Technical Memorandum

To: Veronica Sannes – Minnehaha Creek Watershed District
From: Michael McKinney, PE, Bryan Pitterle, PE and Sarah Stratton, CFM – Barr Engineering Co.
Subject: York Pond: Hydraulic and Hydrologic Design Review, Version 1
Date: December 3, 2025; Updated April 10, 2026
Project: 23272052.00
c: Ross Bintner – City of Edina

6.1 Response to MCWD Permitting Review Design Questions

FIGURE 1

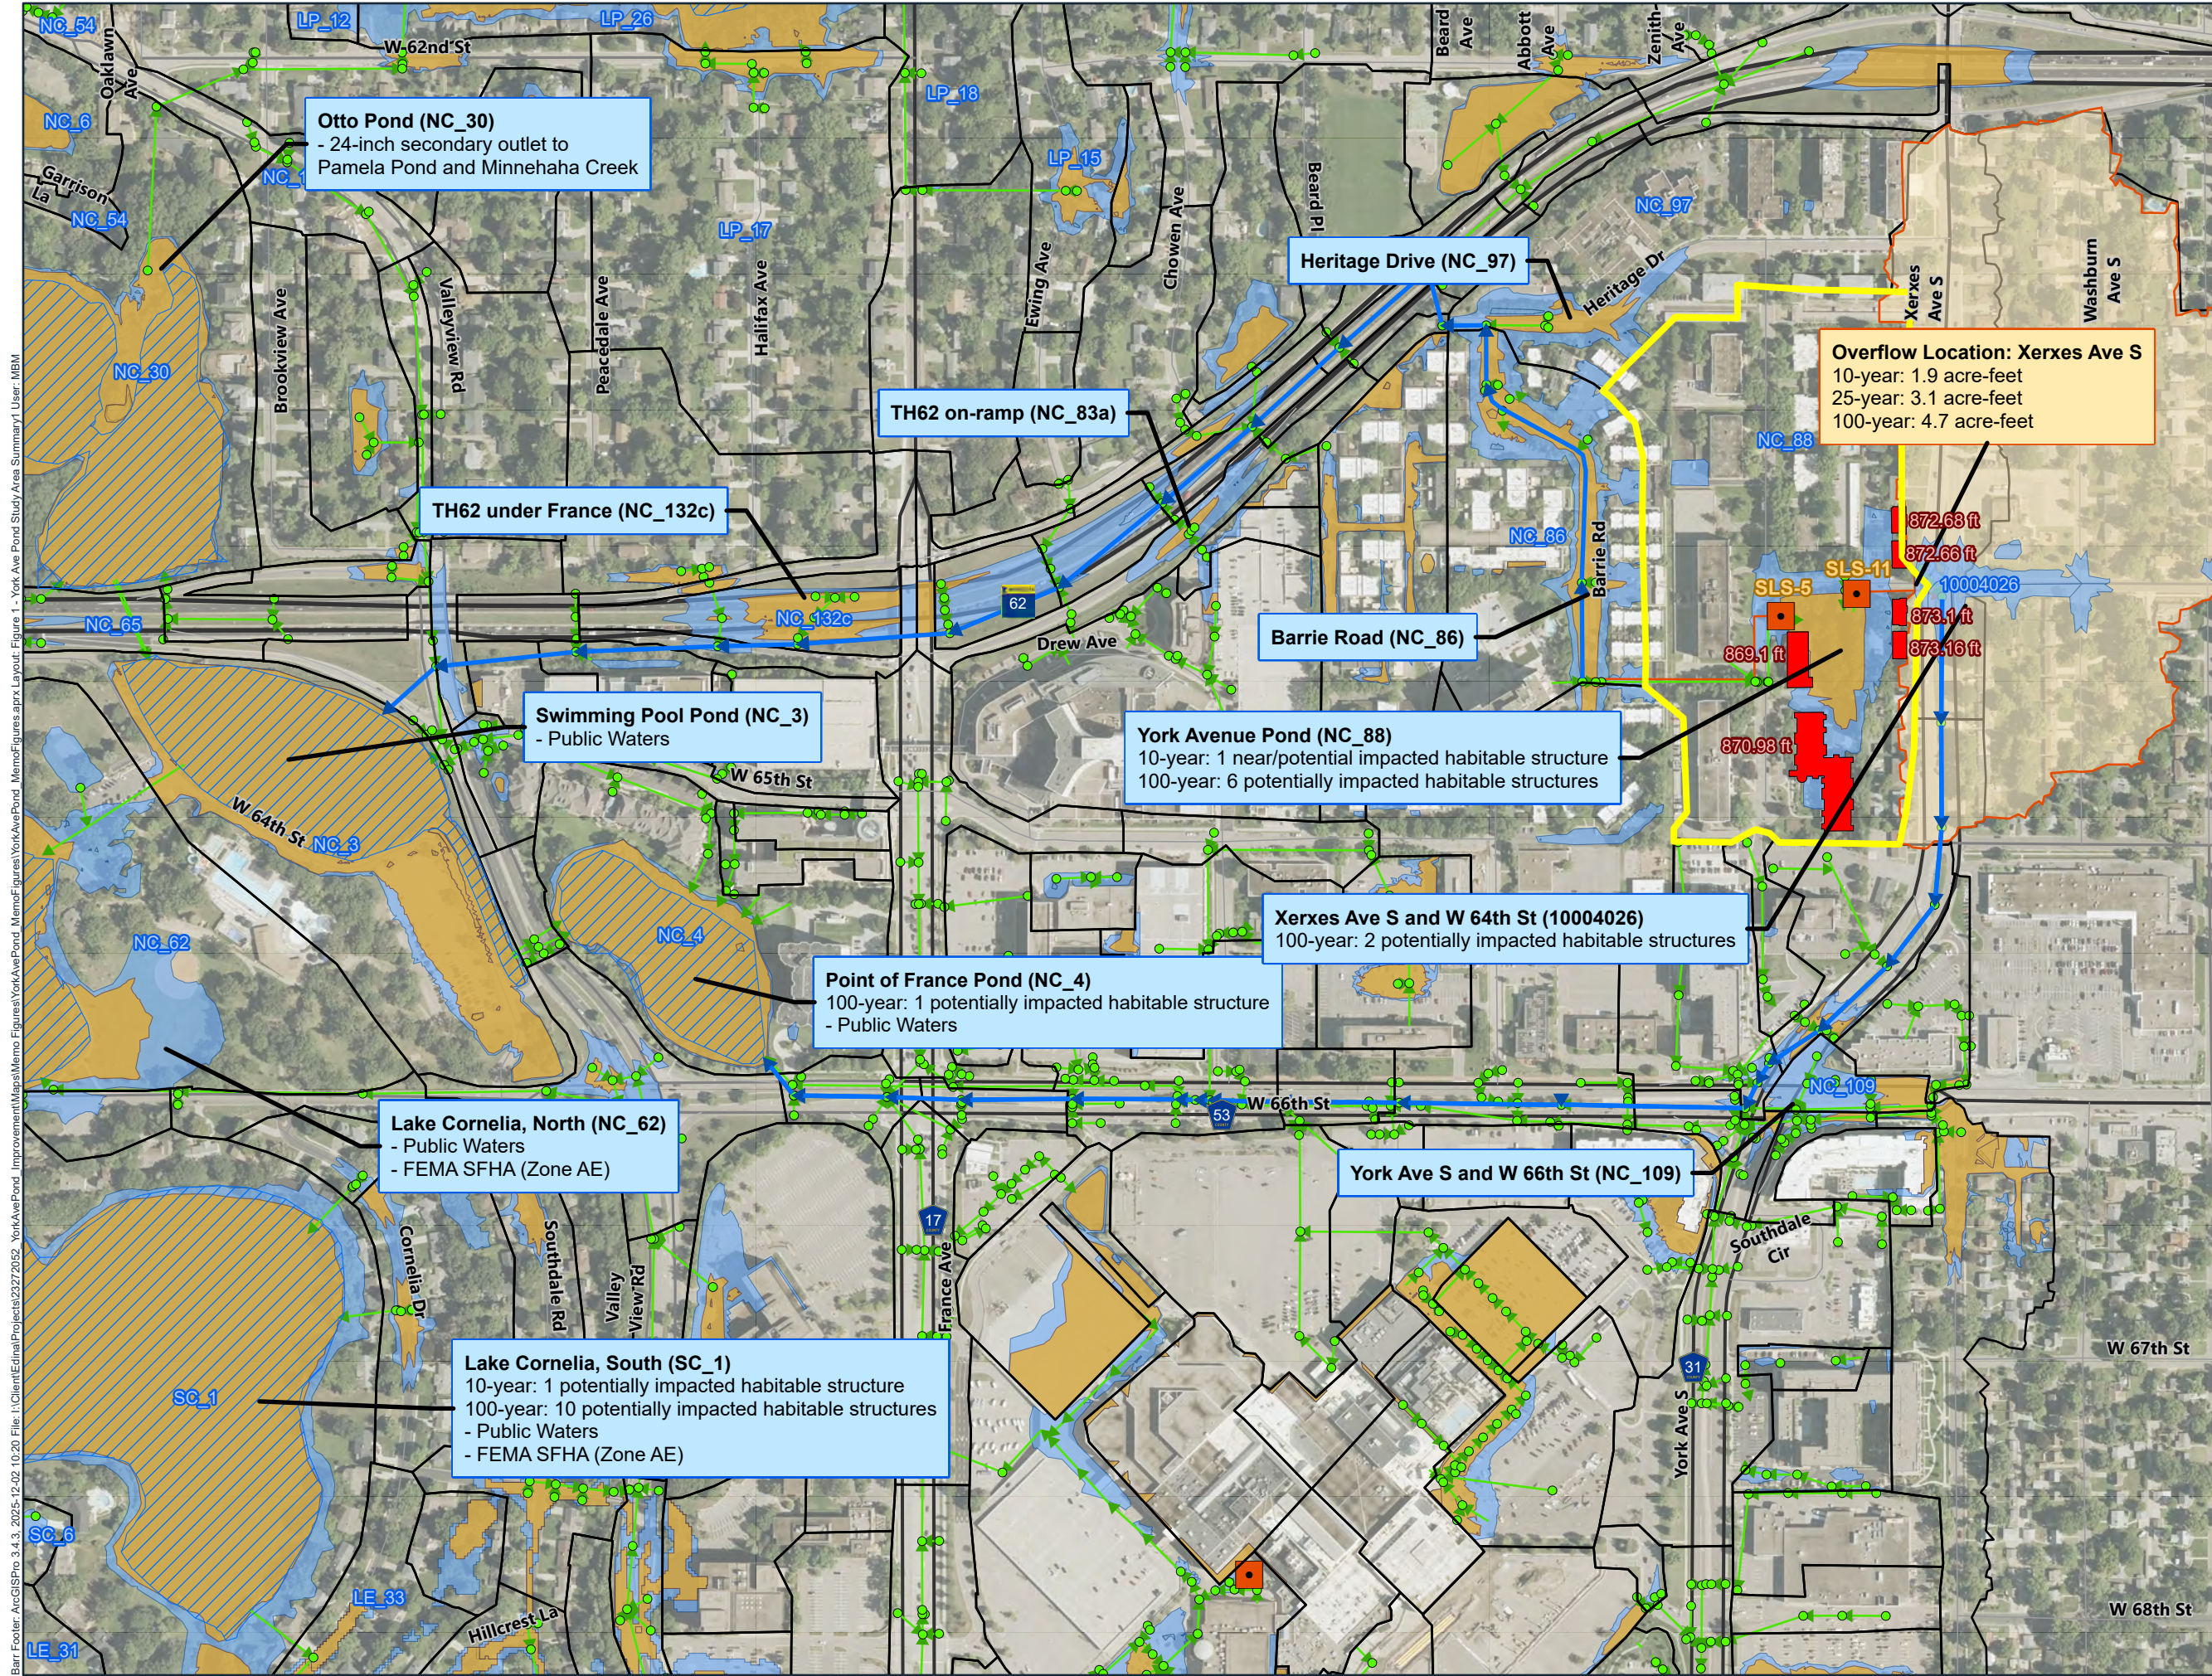
Comment: Please include justification of the increase in pump capacity from 1,000 GPM to 2,000 GPM into the Barrie Road storm sewer.

Response: increasing the total pump rate to Barrie Road from 1,000 GPM to 2,000 GPM was incorporated into proposed York Pond lift station operation plan for the following two reasons:

- 1) As noted in Section 2 and Figure 1, flood volume along the low area located at W 64th Street and Xerxes Avenue overflows into York Pond. For this reason, when pumping to this location during large events, a portion of the pumped volume overflows (i.e., recirculates) back into York Pond, reducing the efficiency of pumping to this location.

- 2) Although the current operation plan ensures that cumulative outflow capacity from York Pond never exceeds the existing maximum outflow rate of 2,000 GPM, the design allows for flexibility to modify operation in the future in response to changing downstream conditions (i.e., downstream flood mitigation projects that may allow for additional outflow rate from York Pond). The current design would support a maximum outflow rate of up to 3,000 GPM in the future. Evaluation of modification of the York Pond lift station operational plan to increase total outflow capacity would be done in conjunction with, or following, implementation of downstream flood mitigation projects.
